Access Compliance Report Public Rights-of-Way (Curb Ramps)

Main Street: WYNDHAM_ST **Cross Street:** EDENDALE_ST **Location:** S

ADA ID: RPRK211020152909 **Ramp Type:** Type 4 - Parallel **Initial Pass/Fail:** Fail **Overall Compliance:** No **Severity Score:** 16

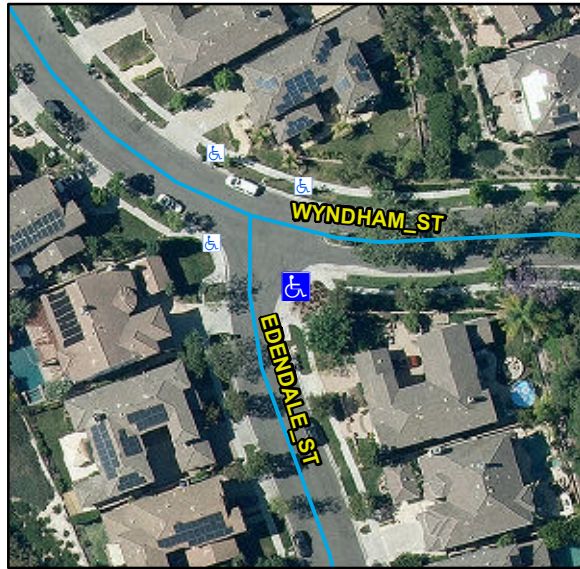
Compliance	Description	Data	Compliance	Description	Data
N/A	Ramp Length LT (in)	121	N/A	Ramp Length RT (in)	116
Yes	Ramp Width LT (in)	55	Yes	Ramp Width RT (in)	54
No	Ramp Run Slope LT (%)	8.4	Yes	Ramp Run Slope RT (%)	0.2
No	Ramp Cross Slope LT (%)	3.1	Yes	Ramp Cross Slope RT (%)	0.9
N/A	Landing Present	N/A	N/A	DWS Provided	N/A
N/A	Landing Length (in)	N/A	N/A	DWS Contrast	N/A
N/A	Landing Width (in)	N/A	N/A	DWS Length (in)	N/A
N/A	Landing Run Slope (%)	N/A	N/A	DWS Full Width	N/A
N/A	Landing Cross Slope (%)	N/A		DWS Offset Type	N/A
N/A	Landing Movement Obstructed?	N/A	N/A	DWS Offset Left (in)	N/A
	Landing Movement Type	N/A	N/A	DWS Offset Right (in)	N/A
N/A	Landing Shared	N/A			
N/A	Clear Space	Yes			
N/A	Clear Space To Crosswalk (in)	N/A			
N/A	Marked Crosswalk 1	No	N/A	Marked Crosswalk 2	No
	Crossing 1 Direction	NE		Crossing 2 Direction	NW
N/A	Marked Crosswalk 1 Width (in)	N/A		Marked Crosswalk 2 Width (in)	N/A

N/A	Ramp Inside Crosswalk 1	N/A	N/A	Ramp Inside Crosswalk 2	N/A
	Crossing 1 Slope (%)	5.1		Crossing 2 Slope (%)	0.4
	Crossing 1 Cross Slope (%)	4.6		Crossing 2 Cross Slope (%)	1.9
N/A	Gutter Ponding	N/A	N/A	Curb Slope	4.9
Yes	Gutter Lip Height (in)	0		Road Run Slope (%)	2.3
N/A	Gutter Run Slope (%)	N/A		Road Cross Slope (%)	2.9
N/A	Gutter Cross Slope (%)	N/A	No	Perpendicular Joint Present	No
Yes	Overall Surface Condition	Acceptable			
	Cross Gutter Present?	No		Spandrel Present?	No
	Replace Cross Gutter?	N/A		Replace Spandrel?	N/A

Possible Solutions:
Remove & Replace Curb Ramp With Two New Directional Ramps or Equivalent.

OC Std/PROW:
 R204.3, R304.3.2, R304.5.3, STD 1115
